INDESIT company

Model type:
BAN18G

Commercial code:
F034723

n1030093: New fixing of evaporator on static fridge-freezers (05 range) 60 cm,Melano

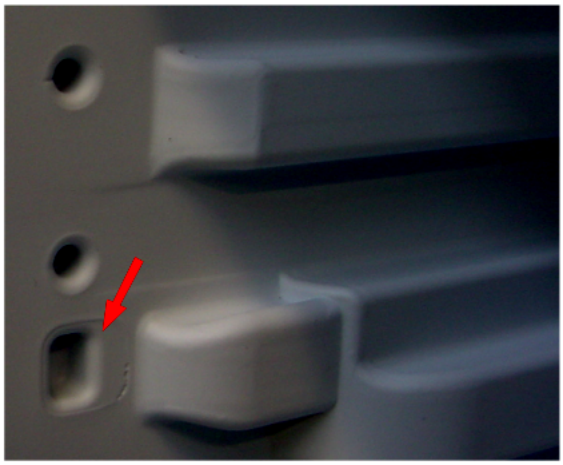
From August 05 (serial no. 50802.0001) the freezer evaporator is secured to the cabinet by a plastic profile.
The cabinet walls have been modified to create locations to house the profile, which is installed on the front of each evaporator plate (see photo N1030093fig1- fig2 - fig3)
The profile cannot be fitted on premodification appliances, so technical personnel must continue to fit the rh and lh supports on these models (see photo N1030093fig4)

Parts replaced
C00075596 = EVAPORATOR RH SUPPORT
C00075597 = EVAPORATOR LH SUPPORT

New parts
C00141135 = WHITE PROFILE L=443.5 MM

n1030094: New fixing of evaporator on static fridge-freezers (05 range) 60 cm, Lodowek

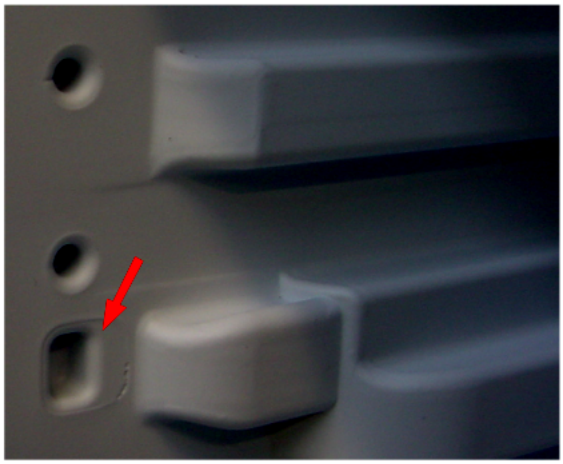
From August 05 (serial no. 50820.0001) the freezer evaporator is secured to the cabinet by a plastic profile.
The cabinet walls have been modified to create locations to house the profile, which is installed on the front of each evaporator

plate (see photo N1030093fig1- fig2 - fig3)
The profile cannot be fitted on premodification appliances, so technical personnel must continue to fit the rh and lh supports on these models (see photo N1030093fig4)

Parts replaced
C00075596 = EVAPORATOR RH SUPPORT
C00075597 = EVAPORATOR LH SUPPORT

New parts
C00141135 = WHITE PROFILE L=443.5 MM
